ROCKY FLATS SITE

REGULATORY CONTACT RECORD 2022-05

Purpose: Solar Ponds Plume Treatment System (SPPTS) discharge gallery maintenance

Figure 1. SPPTS Discharge Gallery Maintenance Overview

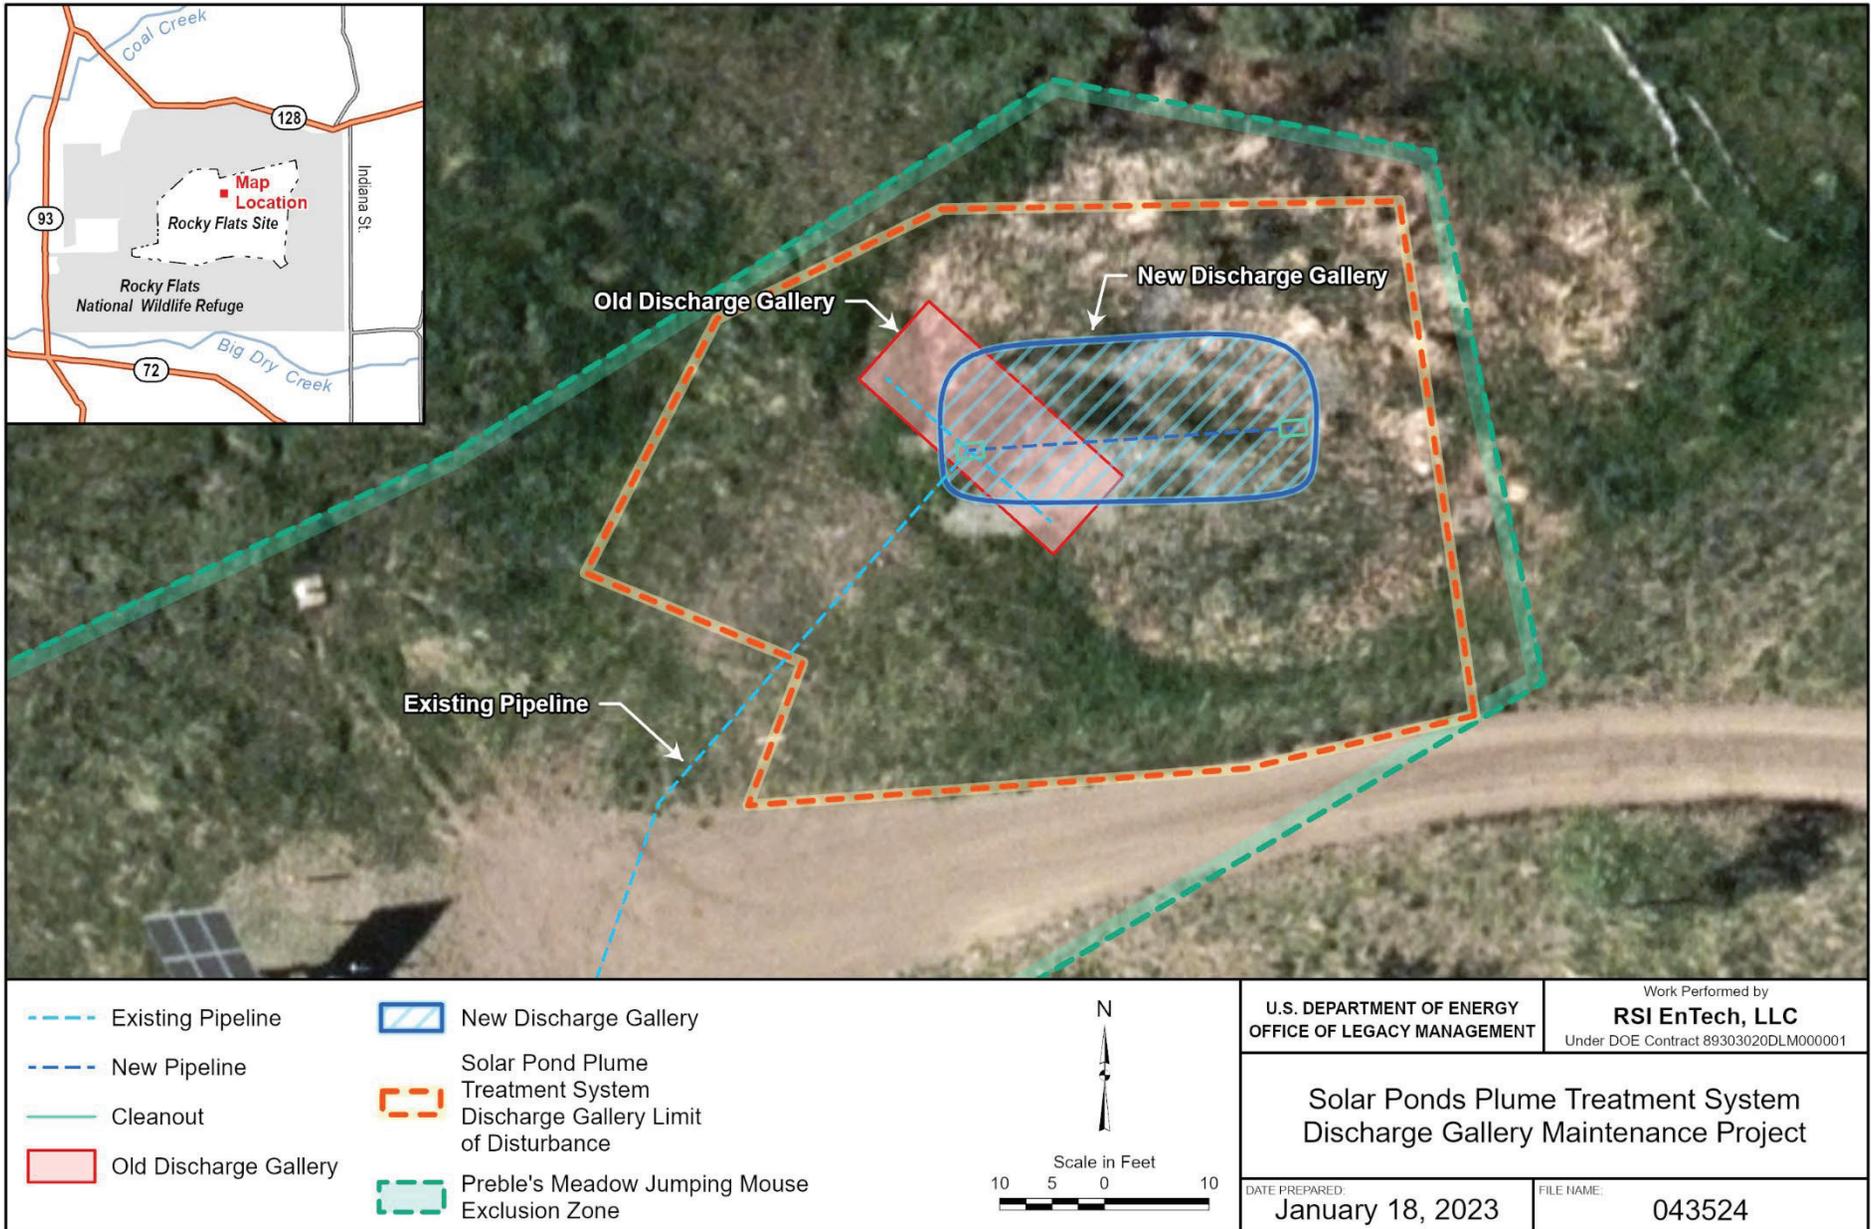
Within the resulting excavation, DOE will install new pipe bedding consisting of washed gravel, geotextile, and riprap. The base of this bedding will be 3–5 ft below grade. DOE will then install a new 30 ft long, 4-inch perforated discharge pipe and tie it into the existing discharge pipeline from the treatment system at an approximate depth of 2.5 ft. DOE will then backfill the excavation with bedding material to the original grade or higher.

DOE will conduct all project-related activities within the PMJM exclusion zone or on existing roadways. The project will delineate the disturbance limits boundary (<0.09 acre) in the field by construction fencing (or similar) to keep all work within the designated work footprint. DOE notified USFWS of the planned SPPTS discharge gallery activities on January 9, 2023. No response from USFWS is needed or expected.

Resolution: CDPHE, after consultation with EPA, has approved the activities described in this contact record (CR) as documented in its 2022-05 Contact Record letter to DOE. Based on the information provided, CDPHE determined that the proposed activities will not result in an unacceptable release of or exposure to residual subsurface contamination and will not damage any component of the remedy. CDPHE has also determined that the proposed activities meet the rationale and objectives of IC 2.
